Date: September 20, 2007

To: T10 Committee (SCSI)

From: George Penokie (IBM)

Subject: SAS-2: Initiator Write Transport Layer Write Flowcharts

Figure 4 — Representation of transport layer (i.e., ST_ITS5) write data operation

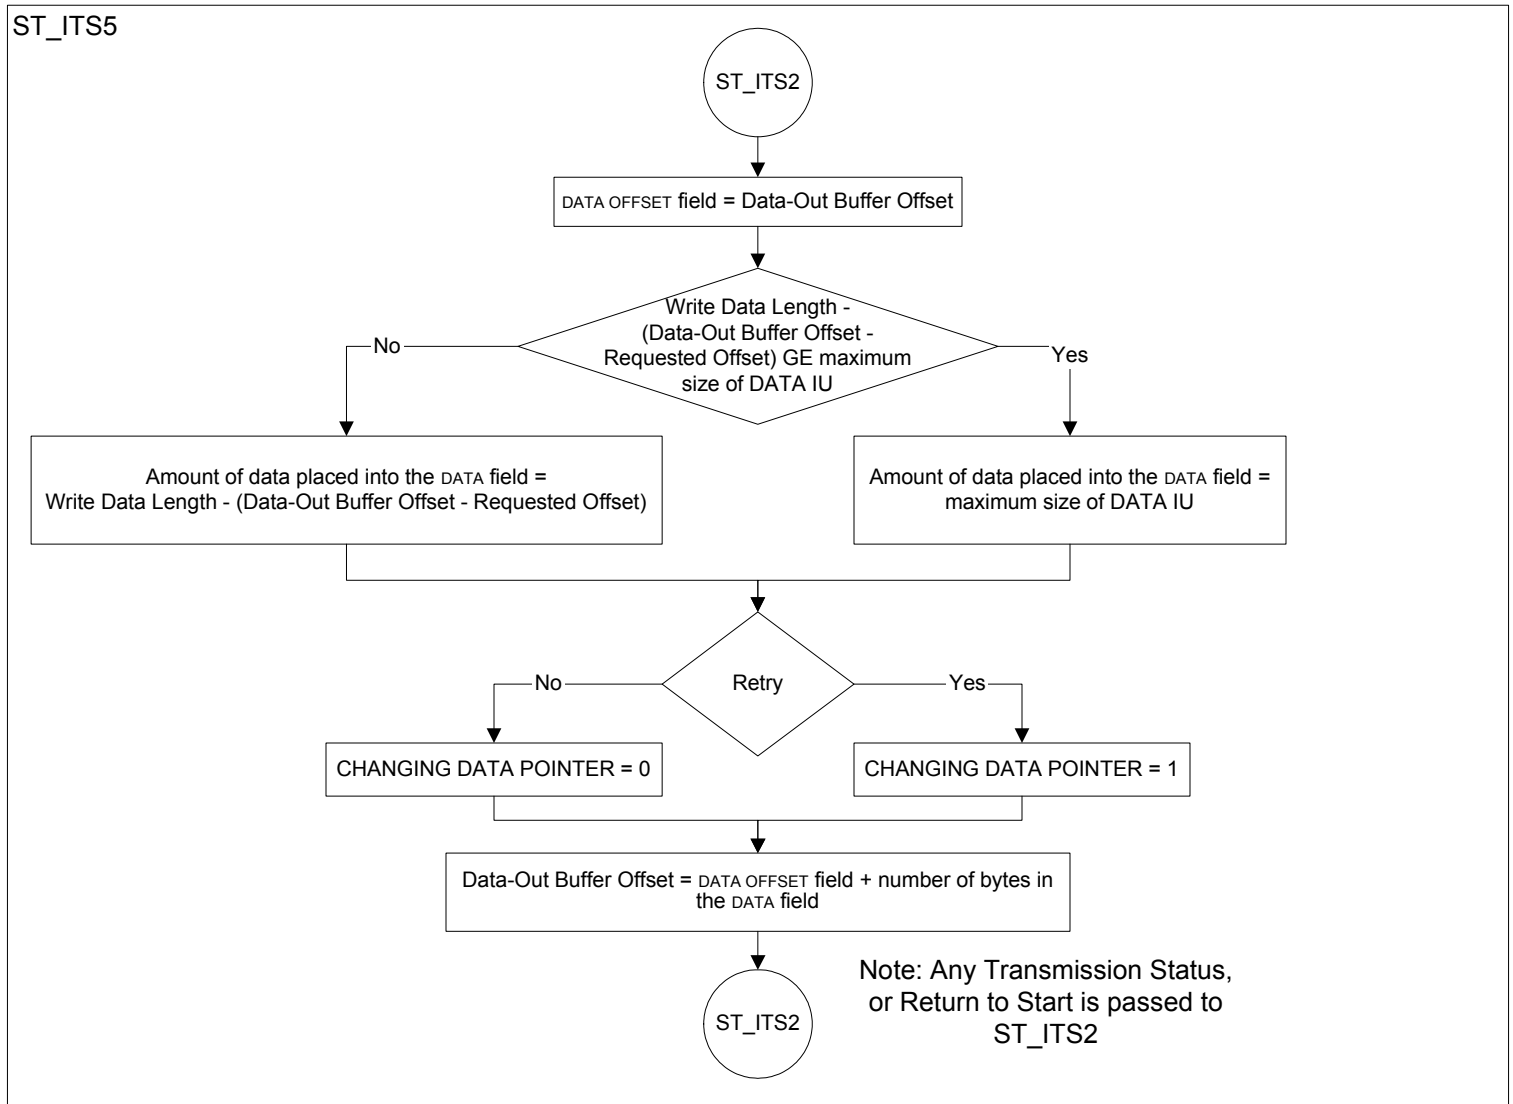
- j) DATA OFFSET field set to the Data-Out Buffer Offset state machine variable;
- ~~k) in the information unit, DATA field set to the information that starts at the location in the Data-Out Buffer state machine argument pointed to by the Data-Out Buffer Offset state machine variable and shall contain the amount of data indicated by the Write Data Length Xfer_Rdy argument; and~~

- l) in the information unit, set the DATA field to the information that starts at the location in the Data-Out Buffer state machine argument pointed to by the Data-Out Buffer Offset state machine variable. If the number of bytes remaining to be transferred as defined by the following calculation:

bytes remaining to be transferred = Write Data Length Xfer_Rdy state machine argument - (the Data-Out Buffer Offset state machine argument - Requested Offset Xfer_Rdy state machine argument)

is equal to the maximum size of the write Data information unit, then the amount of data shall be the maximum size of the write Data information unit. Otherwise, the amount of data shall be the lesser of:

A) the bytes remaining to be transferred; and
B) the maximum size of the Write information unit.
- m) fill bytes, if any.
